Attachment 2

Proposed Technical Specification Changes

Unit 1 Technical Specifications

AXIAL FLUX DIFFERENCE (AFD)

FIGURE 3.2-1 AXIAL FLUX DIFFERENCE LIMITS AS A FUNCTION OF RATED THERMAL POWER

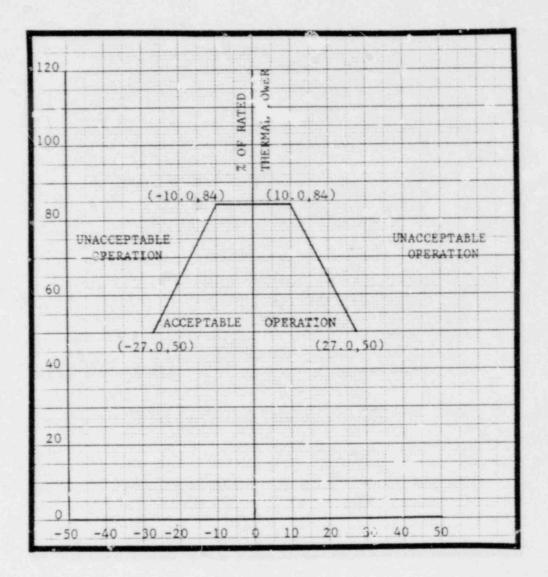
- 2) The indicated AFD is within the limits shown on Figure 3.2-1. Otherwise, reduce THERMAL POWER to less than 50% of RATED THERMAL POWER within 30 minutes and reduce the Power Range Neutron Flux-High Trip Setpoints to less than or equal to 55% of RATED THERMAL POWER within the next 4 hours.

- b) Surveillance testing of the Porer Range Neutron Flux Channels may be performed pursuant to Specification 4.3.1.1.1 provided the indicated AFD is maintained within the limits of Figure 3.2-1. A total of 16 hour of operation may be accumulated with the AFD outside of the target band during this testing without penalty deviation.

Figure 3.2-2 K(Z) - Normalized $F_Q(Z)$ as a Function of Core Height

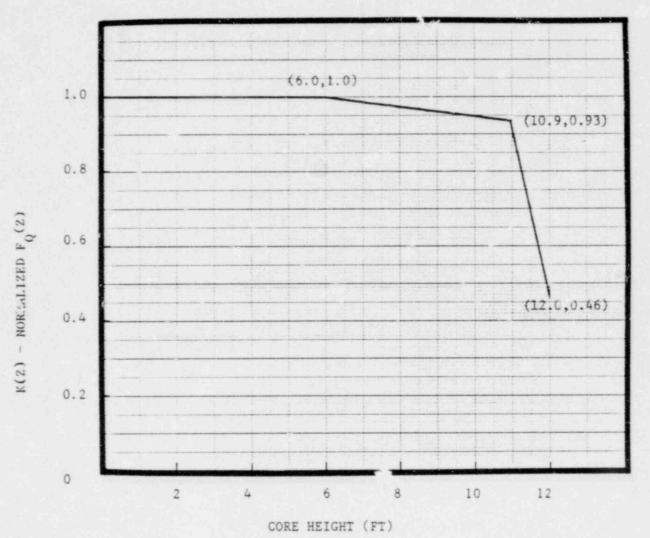
$F_Q(Z) \leq [2.14] [K(Z)] \text{ for } P > 0.5$ $F_{12}(Z) \geq [4.28] [K(Z)] \text{ for } P \leq 0.5$ where $P = \frac{\text{THERMAL POWER}}{\text{RATED THERMAL POWER}}$

and K(Z) is the function obtained from Figure 3.2-2 for a given core height location.

Figure 3.2-1 Axial Flux Difference Limits as a Function of Rated Thermal Power

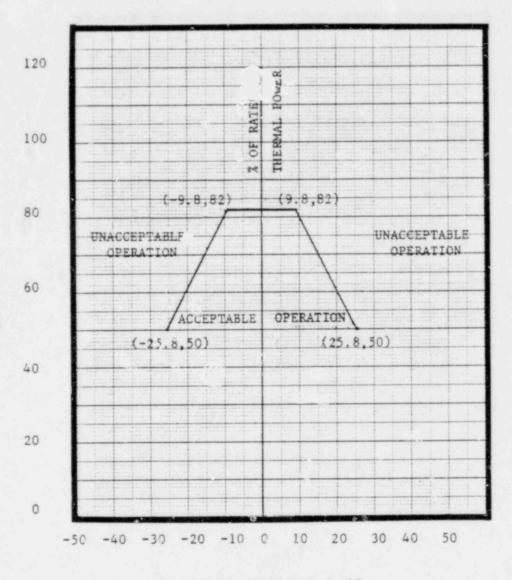
- 2) The indicated AFD is within the limits shown on Figure 3.2-1. Otherwise, reduce THERMAL POWER to less than 50% of RATED THERMAL POWER within 30 minutes and reduce the Power Ringe Neutron Flux-High Trip Setpoints to less than or equal to 55% of RATED THERMAL POWER within the next 4 hours.

- b) Surveillance cesting of the Power Range Neutron Flux Channels may be performed pursuant to Specification 4.3.1.1.1 provided the indicated AFD is maintained within the limits of Figure 3.2-1. A total of 16 hours of operation may be accumulated with the AFD outside of the target band during this testing without penalty deviation.

Figure 3.2-2 K(Z) - Normalized $F_Q(Z)$ as a Function of Core Height

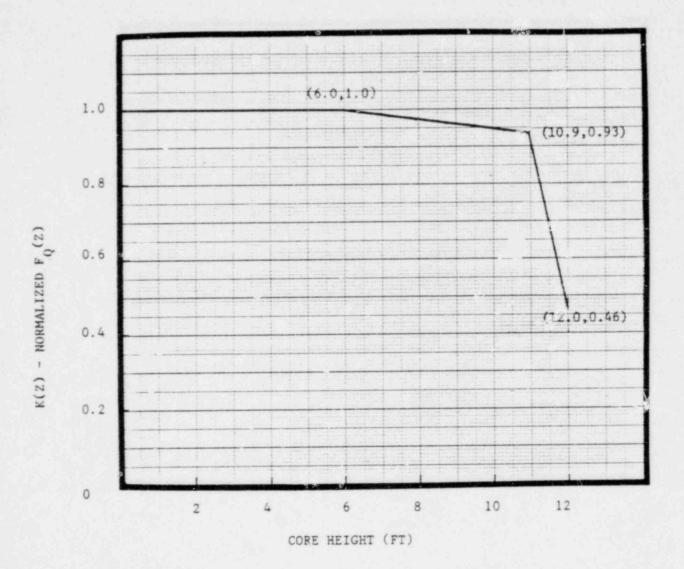
$F_Q(Z) \leq [2.14] [K(Z)] \text{ for } P > 0.5$ $F_Q(Z) \leq [4.28] [K(Z)] \text{ for } P \leq 0.5$ where P = THERMAL POWER

and K(Z) is the function obtained from Figure 3.2-2 for a given core height location.
